DEVELOPMENT ASSESSMENT REPORT				
Application No.	DA/2021/0861			
Address	356 Canterbury Road HURLSTONE PARK NSW 2193			
Proposal	Construction of three storey 88 place childcare centre with basement parking.			
Date of Lodgement	15 September 2021			
Applicant	ArtMade Architects			
Owner	Mr Aashish A Ali Mr Mustak Shaikh Mr Zaffar Hussain Mr Mustak Shaikh Mrs Preeti Shaikh Mr Ashfaq G Shaikh Mrs Maniza Shaikh Mr Syedda F Ali Mrs Azharuddin Ali			
Number of Submissions	Initial: 11			
Value of works	\$3,429,185.00			
Reason for determination at Planning Panel	Number of submissions			
Main Issues	Submissions, car stacker parking, vehicular access to 352 Canterbury Road.			
Recommendation	Approved with Conditions			
Attachment A	Recommended conditions of consent			
Attachment B	Plans of proposed development			
Attachment C	Plan of Management			
Attachment D	Operational Waste Management Plan

This report is an assessment of the application submitted to Council for the construction of three storey 88 place childcare centre with basement parking at 356 Canterbury Road HURLSTONE PARK NSW 2193.

Figure 2: Estimate dimensions for stacked parking system

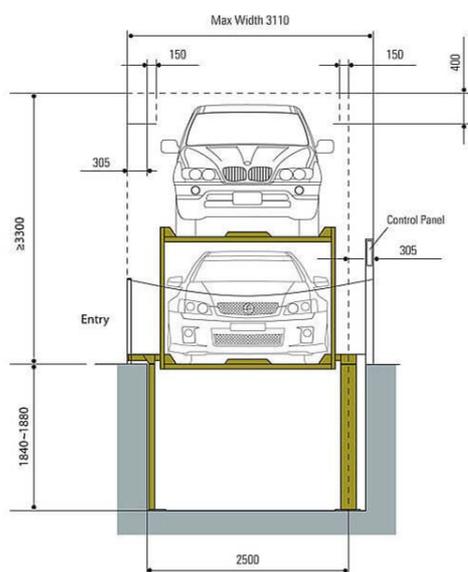
A review of 4 of the proposed staff parking spaces (number 6 to 9) has highlighted a request for mechanical stacked parking. This request has been reviewed by Council and is not supported due to insufficient information. The current application has failed to provide required details on the proposed car parking stacking system to enable a detailed assessment. In particular concerns are raised that the basement has not been designed to accommodate a car parking stacking system, with the basement proposed to accommodate floor to floor heights of 3.1m. Any car parking stacking system is anticipated to require a minimum pit depth of 1.8 – 2m and a clearance (head height) of 3.3m (as seen within figure 2 below). At this time these dimensions or any other documentation to support stacked car parking has not been provided to Council, as such a condition requiring the deletion of the stacker car parking is recommended.

The imposition of the condition requiring the deletion of the stacker car parking spaces, results in the development having a short fall in parking by two spaces, resulting in a total on site parking rate of 20 spaces. This variation is considered to be minor and acceptable, given the sites location within a commercial centre and proximity to Hurlstone Park rail line (roughly 650m away). A condition requiring the provision of 10 staff parking spaces and 10 visitor parking spaces is recommended for the consent and the proposed 2 space variation recommended for support.

- a. The proposed car stackers are to be deleted. No car stackers are approved by this consent.
- b. The approved landscape plan and plan of management is to be updated to reflect the conditions of consent and approved architectural plans.

Figure 3: Swept Path diagrams for waste collection

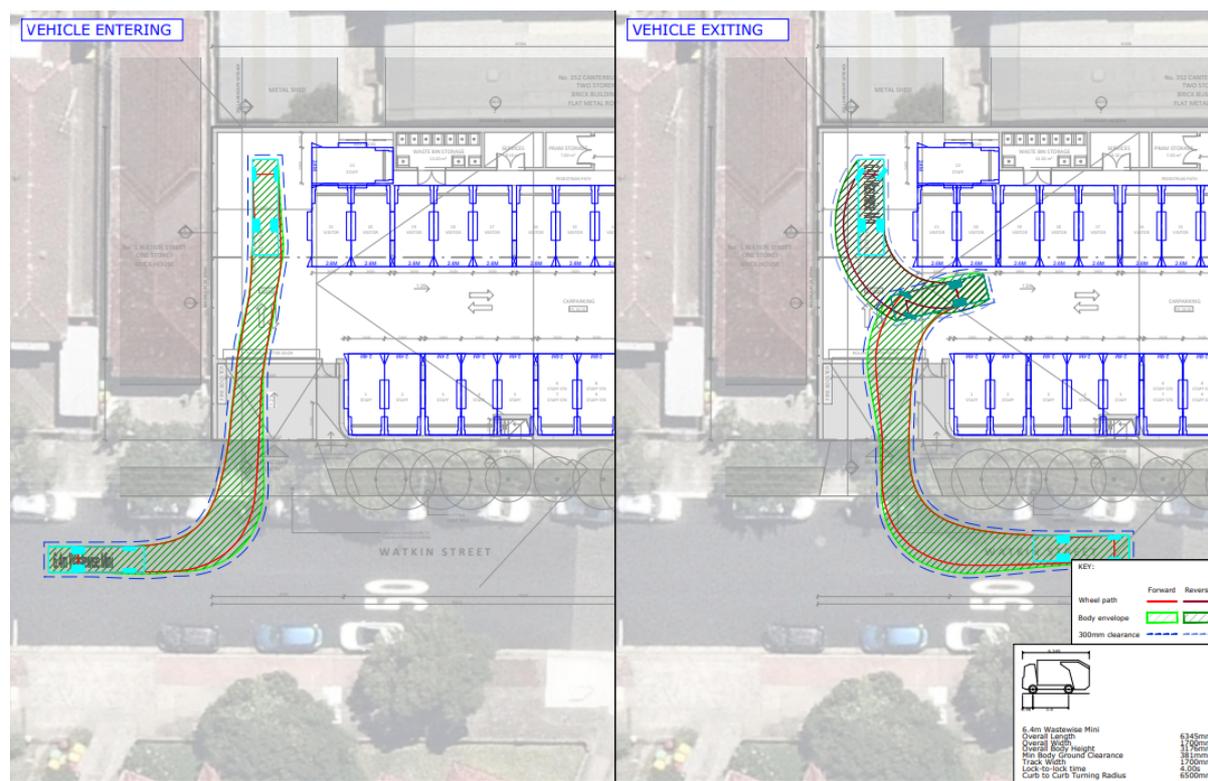
The provided waste management plan has been reviewed by Council’s Resource Recovery Team who outlined that the proposed waste storage areas and rate of collection is sufficient

and compliant with DCP controls. The development is to have collection occur 2 x a week on-site (within the basement), by a private contractor with a truck measuring 6.4m long with a clearance height of 2.1m. The proposed on-site collection method is supported by swept path diagrams which show that the truck is able to enter the basement in a forward direction, reverse within the basement up to car parking space 17 (visitor), collect the waste and then exist the basement in a forward direction. This is outlined within figure 3 below, swept path diagrams provided by applicant. This method of collection is acceptable and ensures minimal impacts on neighbouring residents. To ensure that waste collection does not interfere with residents amenity and operation of the centre, waste collection hours are recommended to be undertaken between 10:00am to 8:00pm.

Figure 4: Map 2 from Chapter D of DCP.

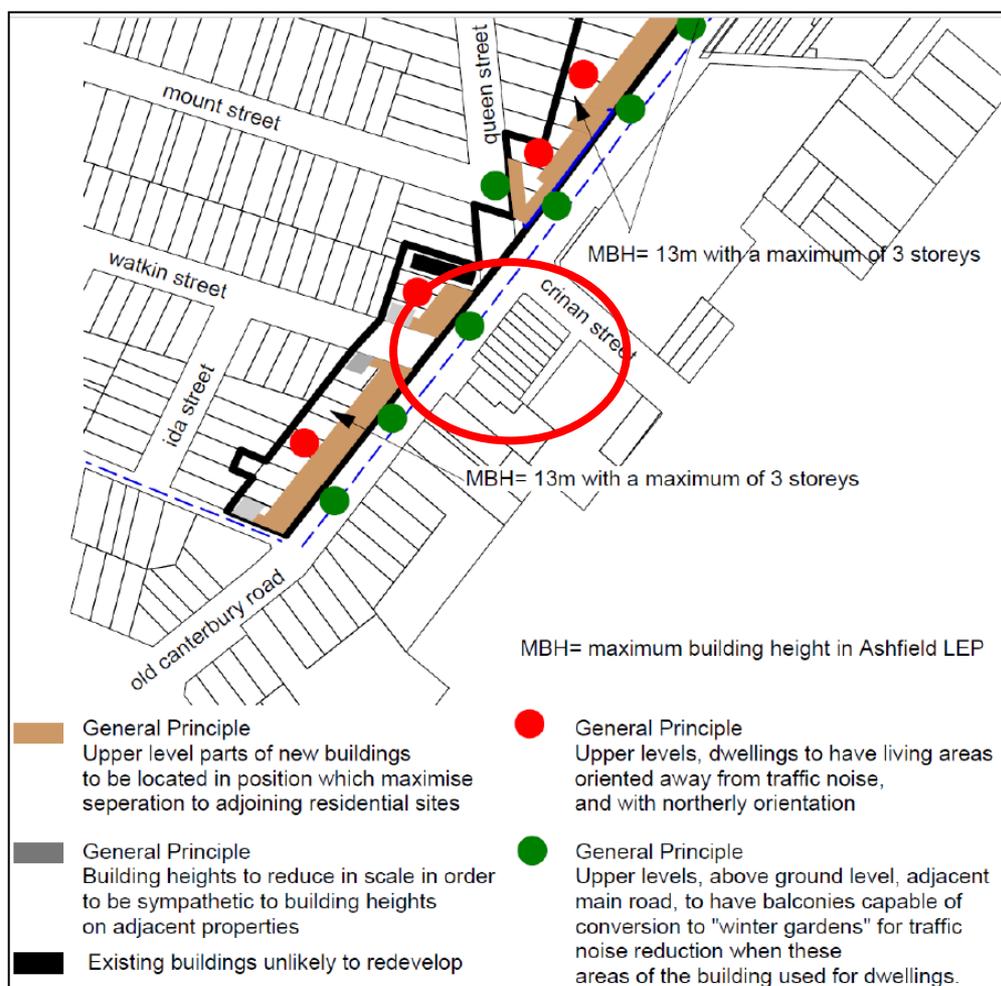
The proposal has been designed generally in accordance with Map 2 in Part 7 Chapter D of the DCP (see Figure 4 below) in that it is 3-storeys in height, has its massing located towards Canterbury Road, maintains substantial separation to the low-scale residential uses at the rear and has nil side setbacks.

Figure 5: Extract of Figure 3 in Chapter D of the DCP.

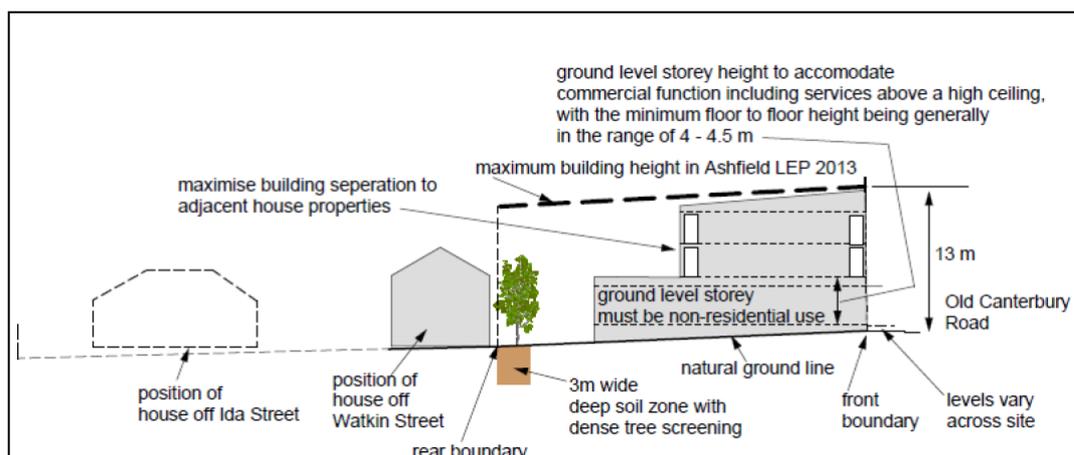
The proposal results in a variation to clause DS4.5 of the DCP, which requires a 3m wide deep landscaped buffer zone to be included along the rear boundary adjacent to the low-density residential dwellings to the west. In this instance the applicant has designed a 2m wide landscape buffer zone relating to the ground floor of the childcare centre. The land slopes from Canterbury Road to the west (rear). Due to the slope of the land the ground level outdoor play area at the rear of the building which is associated with the childcare centre is raised up to 2.7m above ground level (measured to top of planter box). This rear raised ground level portion of the building provides a transition in height from the proposed 3-storey element to the neighbouring single storey dwelling to the west generally in accordance with the intent of Figure 3 in Part 7 Chapter D of the DCP (see Figure 5 below). This building height combined with the proposed 2m wide planter box and 2.5m acoustic fencing provides the intended separation and visual privacy to neighbours, ensuring that children and patrons of the childcare centre are unable to walk to the boundary of the site and view into neighbouring POS or living areas.

The site immediately adjoining this transition is 1 Watkin Street, which does not have any existing windows within the eastern elevation adjoining the western boundary of the subject site (see figure 6 for details). As such impacts of bulk/scale from the proposed 2.7m wall on the western boundary of the subject site are expected to be minimal and the proposed transition acceptable.
